Service Bulletin

S.B. No: 179

Title: INSPECTION OF TAILPLANE ATTACHMENT BRACKETS

This Issue 2 adds repetitive and re-assembly instructions.

FIGURE 2

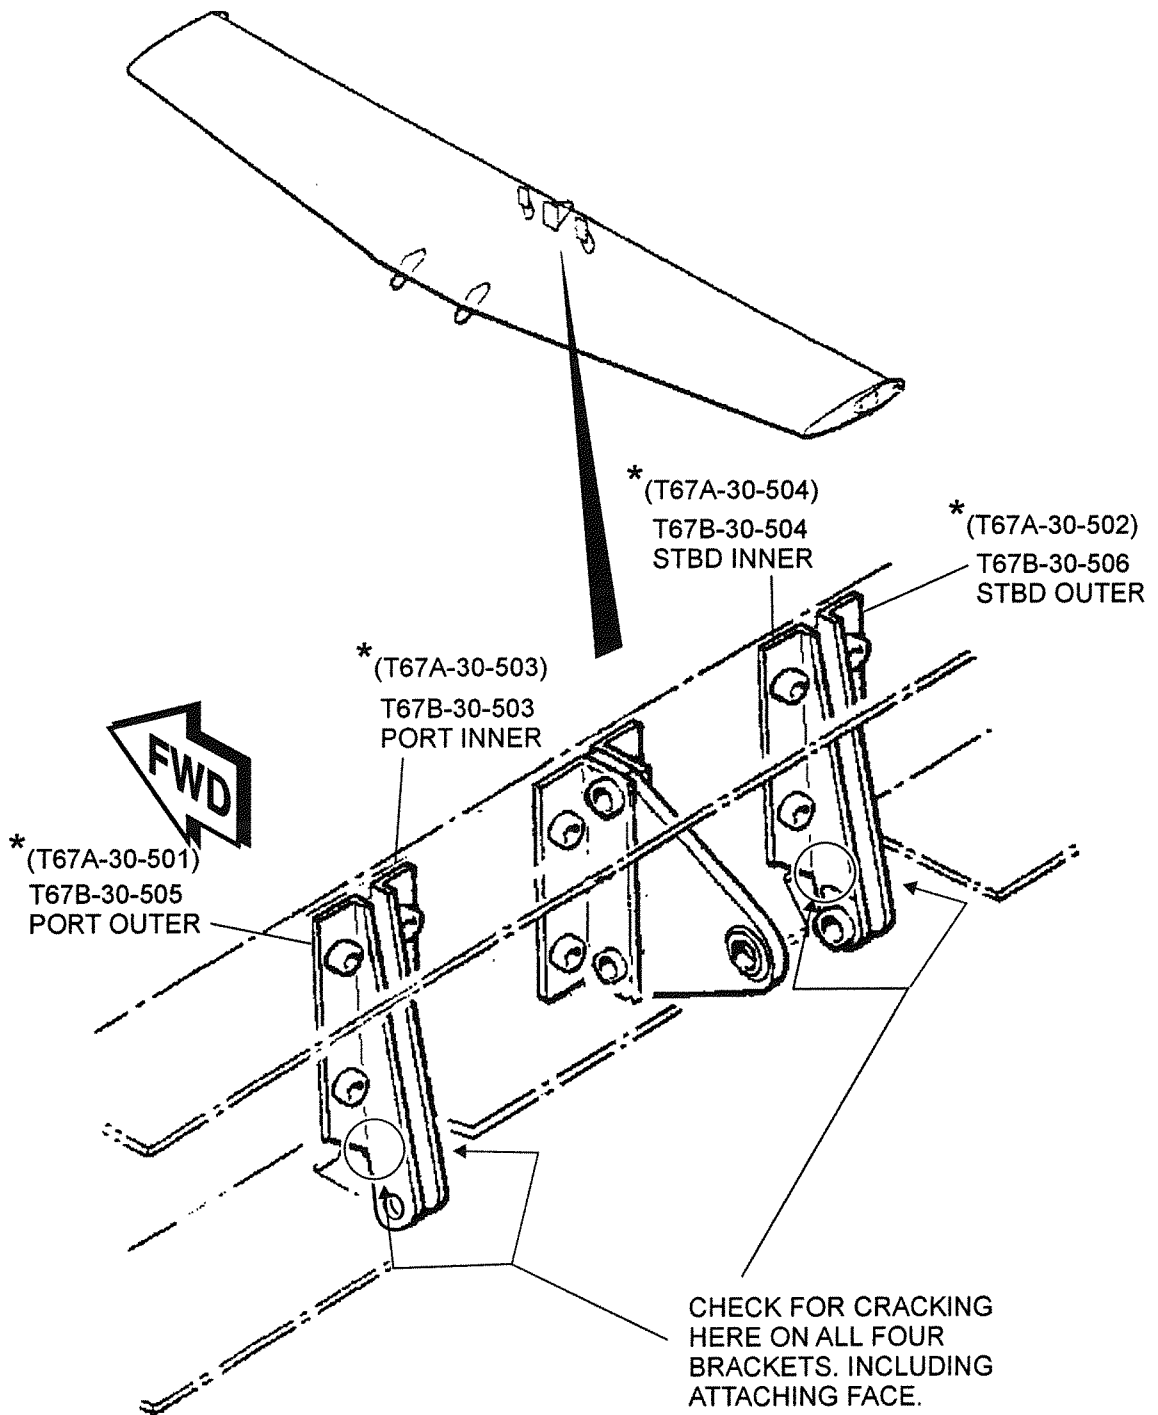
6. Tailplane attachment brackets are to be re-fitted to tailplane, bolts to be "finger tight". The tailplane is to be offered up to the aircraft and main tailplane to fuselage bolts fitted and torqued to 60 lbf in . Then tighten tailplane attachment bracket bolts.

NOTE 1 Prior to torquing main bolts, ensure there is either no gap or a gap of up to a maximum of .010" (.25mm) between fittings. If a gap greater than .010" (.25mm) does exist after taking up slack then it is permissible to fit washers as follows:

Washer/s of thicknesses 0.016" (.4mm) (SAL Stores Code 126-23-750) or 0.018" (.46mm) (SAL Stores Code 126-23-754) or 0.032" (.81mm) (SAL Stores Code 126-23-747). Thinning of 0.032" is acceptable providing faces of washer remain parallel. Re-protect modified face.

NOTE 2 Ensure that the brackets are not forced apart when fitted.

FIGURE 1

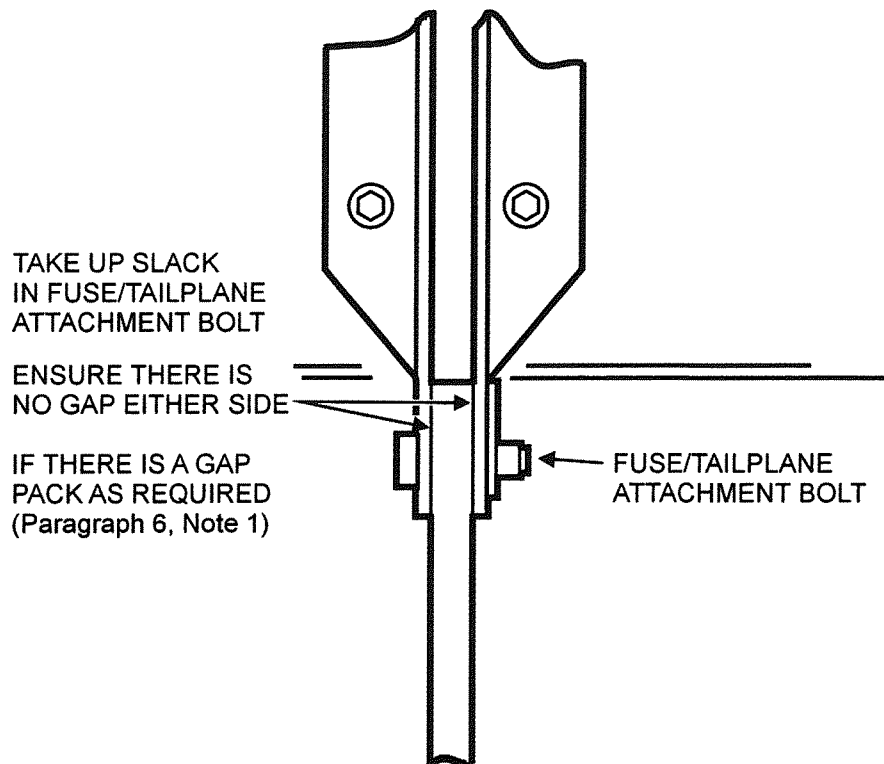
1. Check master switch, ignition switch and fuel are OFF. Disconnect external power and hangar aircraft, if required.
2. Gain access to aft tailplane mounting brackets and remove from tailplane main spar. Ref. Figure 1.

3. Remove paint from bracket.
4. Perform dye penetrant (or similar) NDT crack detection on brackets and examine, paying particular attention to the region illustrated in Figure 1.
5. Should any crack be discovered, then all four tailplane mounted brackets from the subject aircraft shall be returned to SAL and replaced with new items.
